TO: MTA BOARD OF DIRECTORS
FROM: STANLEY G. PHERNAMBUCQ 
SUBJECT: MTA CONSTRUCTION NONCONFORMANCE REPORTS

Attached please find copies of the Nonconformance Reports (NCRs) received by the MTA Director of Quality Management for the week of September 1 - 14, 1995.

NONCONFORMANCE REPORT

ELEVATION - ABUT 12 INTERFACE RETAINING WALL (NORTH)

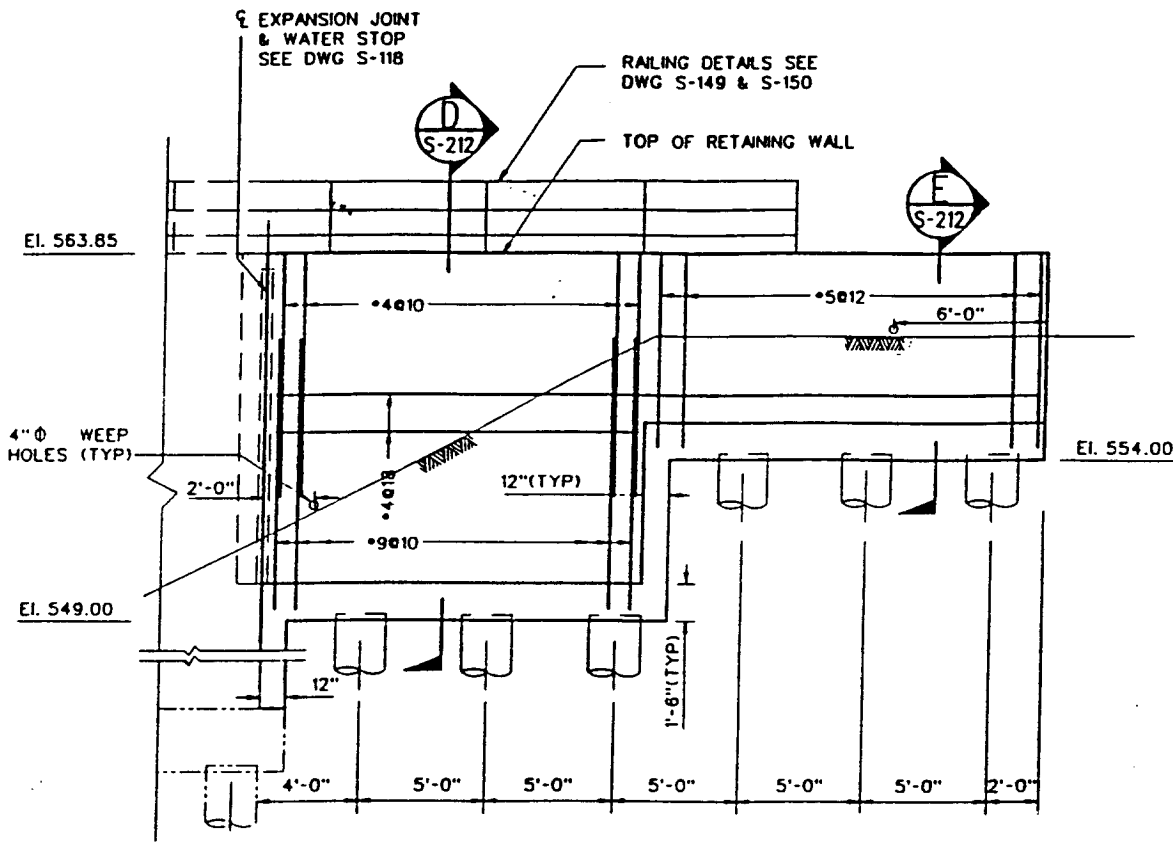
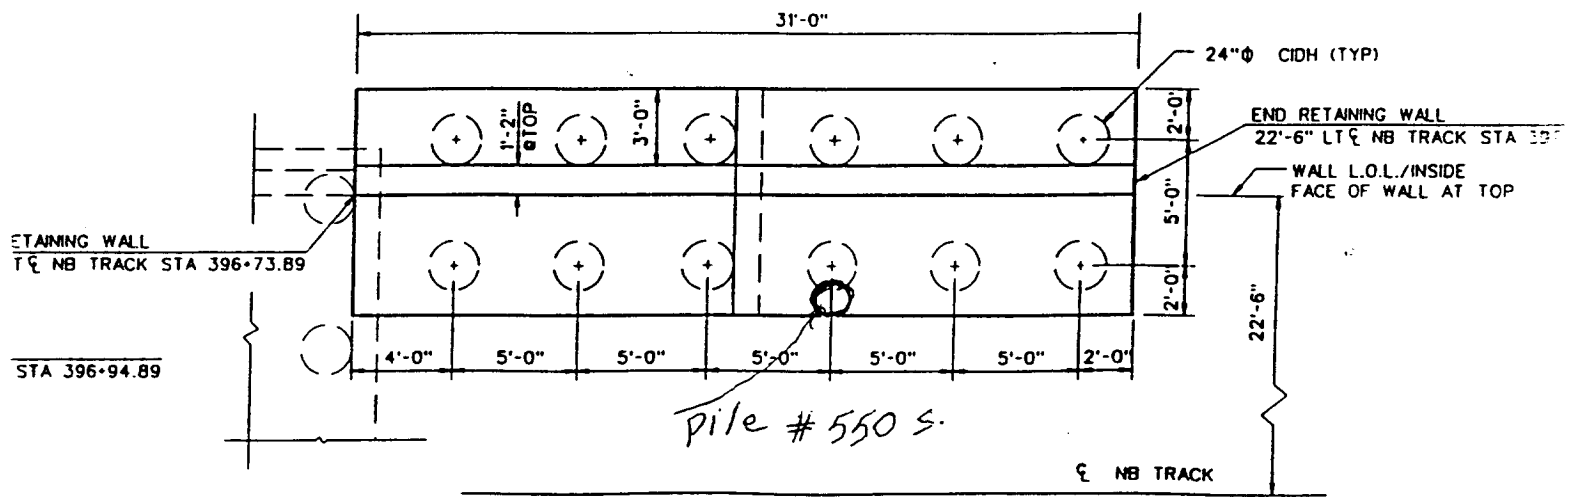
7. Specification/Drawing No.: <i>2387-1.2E, plan sheet # 130</i>			8. Originator: Phone Number: <i>Mohammad Alazzah (213) 258 7284</i>		
9. Nonconformance description and contract requirements: <i>The 24" CIDH pile # 550 S. constructed under abut. 12 interface wall (North) had been shifted toward the edge of the footing by 10" to 12" from it's corrected location according to plan sheet # 130 (see the attached sheet # 2 of 2)</i>

WORK SHEET

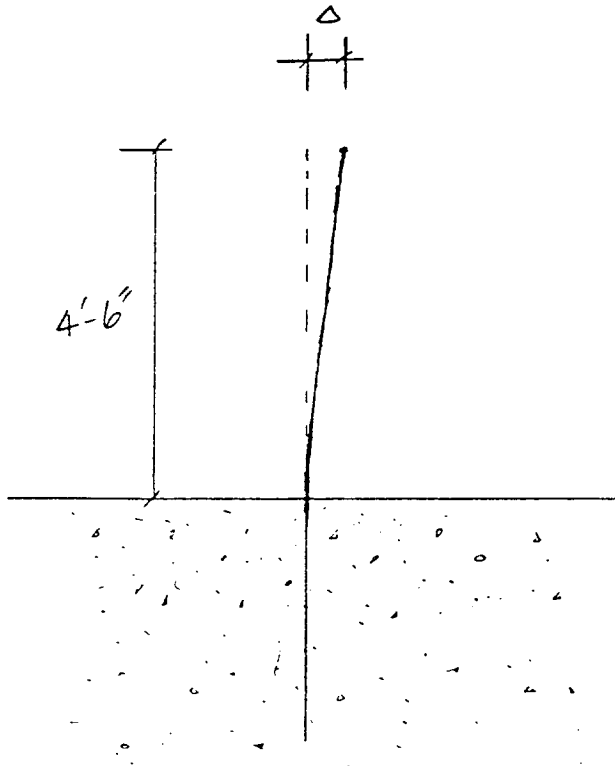
7. Specification Section/Drawing No.:		8. Originator:		Phone No.:	
ACI 318		J. A. Vandrey		913-0095	
				Hold Tag No. N/A	
9. Contract requirement and nonconformance description:					
ACI 318 PARAGRAPH 7.3.2 - REBAR PARTIALLY EMBEDDED IN CONCRETE SHALL NOT BE BENT. FOURTEEN (14) #9 REBARS FOR THE INNER FACE OF THE EXTERIOR WALL, BETWEEN GRID LINES 1 & 6.5, ARE BENT 4" TO 31" OUT OF PLUMB. EXPOSED LENGTH IS 4'-6".

10. Lead Inspector:		Date:		11. Reply requested from:	
Gary Rudy		8/4/95		SHERMAN LEE	
				12. Reply due date:	
				8/11/95	
13. Root cause of the problem and action(s) to prevent recurrence (completed by the contractor):					
DURING THE STRUT REMOVAL & FORMING OPERATION, OUR FIELD PERSONNEL ACCIDENTALLY BENT THE REBARS AS INDICATED ON ATTACHED SHEET 1/3. WE HAVE MODIFIED OUR OPERATION PROCEDURE WHICH WILL PREVENT THE PROBLEM FROM HAPPENING.

BY CONSIDERING THE LOADING & STRUCTURAL BEHAVIOR OF THE EXTERIOR WALL, THE INTERIOR FACE AT THE TOP OF INVERT SLAB WILL GENERALLY BE SUBJECTED TO COMPRESSION FORCE WHICH USUALLY MEANS THE REBAR IS NOT A CRITICAL STRUCTURE COMPONENT. PER ATTACHED ACI CODE, WE PROPOSE TO PROCEED WITH ONE OF THE FOLLOWING CORRECTIVE ACTIONS:

1. STRENGTHENING THE REBAR, THEN CONTINUING WITH VERTICAL REBAR SPLICE.
2. LEAVE BENT REBARS AS-IS AND PROCEED WITH OFFSET SPLICE.

Recommended correction procedure for the bent rebars (Dowels):

1. Thoroughly inspect the existing concrete surface around the bent bars. If there is concrete crack or breakage, repair the defects to meet spec. requirements (Method such as epoxy pressure grout the concrete).
2. Straightening-up the rebars with bent off-set more than 5 inches from their original position. Proper method has to be used for straightening the rebar without damaging the concrete and rebar.
3. Process of straightening-up the bent bars should be gradual and follow all requirements of ACI-318-89 section 7.3.

SURVEY NOTES, 1/10" GRID			FILE 8-252 SANTA Monica		
PARTY CHIEF K. D. Dineby	RECORDER	INSTRUMENT MAN	WEATHER	DATE OF SURVEY 7-27-95	PAGE OF 1 2
SURVEY DESCRIPTION Base Slats As Built			COMPUTED BY K.D	CHECKED BY K.D

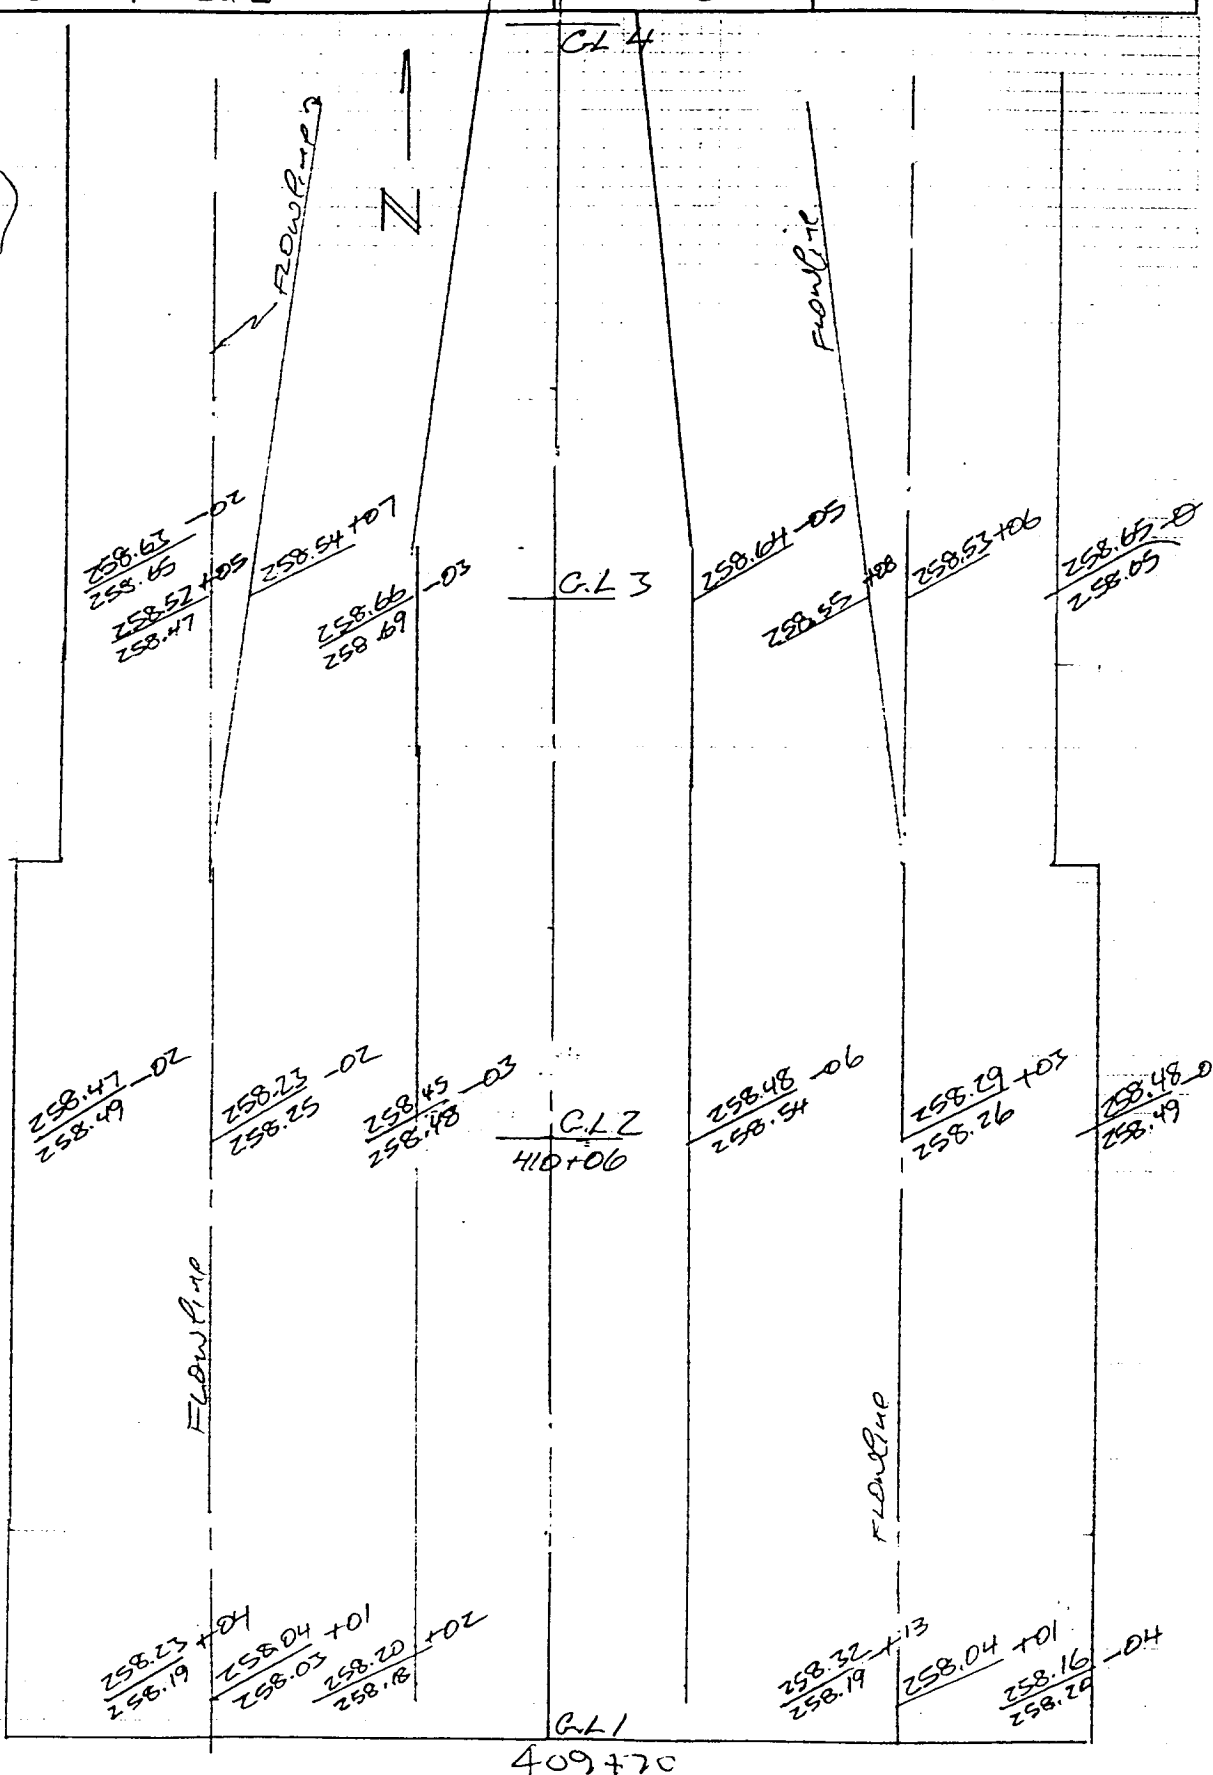
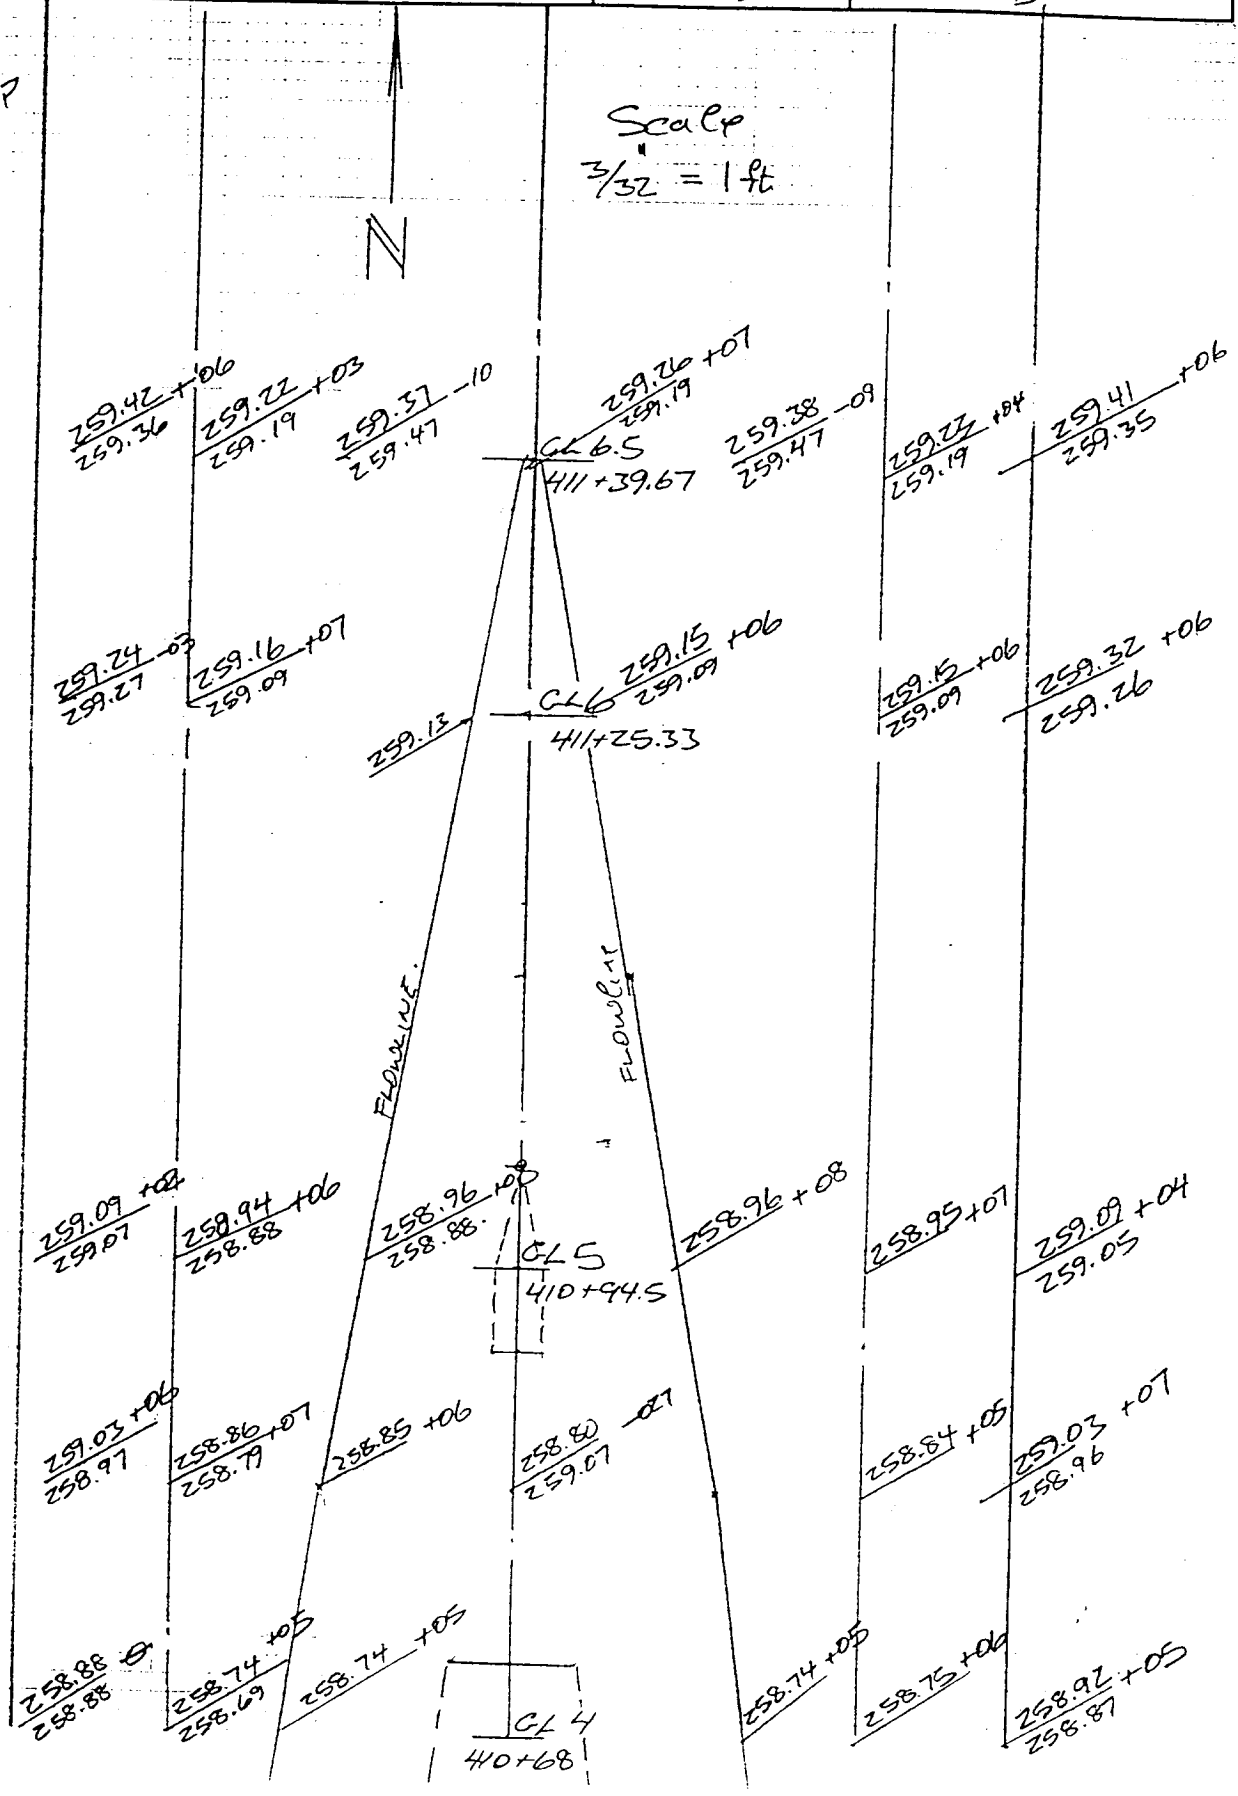
9. Contract requirement and nonconformance description: <i>SPECIFICATION 03300, REQUIRES ELEVATION OF THE INVERT SLAB BE ± 1/4" FROM DESIGN. "AS BUILT" SURVEY OF THE FINISHED SLAB, FROM 409+70 TO 411+39.67 INDICATES THAT THE ELEVATION VARIES FROM + 1 1/2" TO - 1/4" FROM THE DESIGN ELEVATION. (SEE ATTACHMENT #1 & 2)</i>
